BOARD ACTION REPORT – APPEALABLE ITEM

Project Name: 1420 North Swinton Avenue
Project Location: 1420 North Swinton Avenue
Request: Certificate of Appropriateness (COA) and Waiver
Board: Historic Preservation Board
Meeting Date: October 4, 2017

STAFF REPORT

ITEM: 1420 North Swinton Avenue, Clint Moore House, Individually Designated-Certificate of Appropriateness, (2017-149) construction of additions and alterations to the existing single-family residence, construction of a new two-story garage & one-story pool house and Waiver request for an increase to the maximum fence height.

PROPOSED FRONT (NORTH) ELEVATION 1/4" Sc.

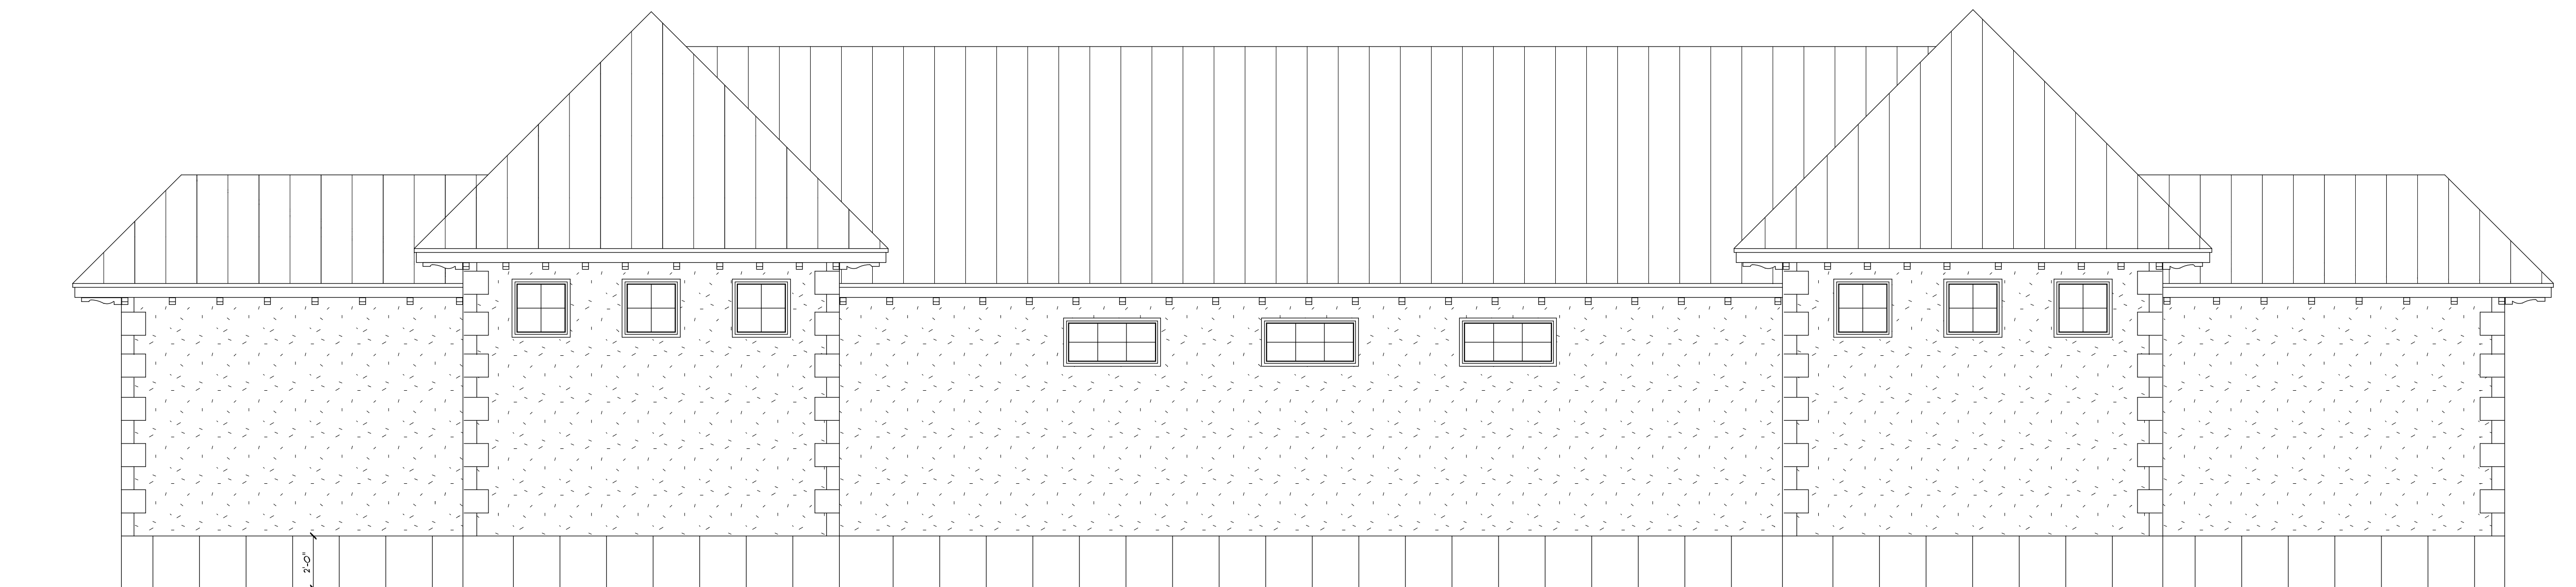
The proposal is for a two-story addition to an existing two-story structure as well as construction of a new two-story garage and a one-story pool house. The requirements of this code section are met as: the first floor maximum height for the residence is 9' and 14'; and, 12'6" for the pool house. The height of first floor of the garage exceeds this requirement as it is proposed at 17'4". A condition of approval has been added to this request to reduce the height of the first floor to not exceed 14'.

1. That the height of the first floor of the garage be reduced to not exceed 14'; and,
2. That the fence, gate posts and entry gates do not exceed 4' in height and that the fence detail be provided on the site plan.
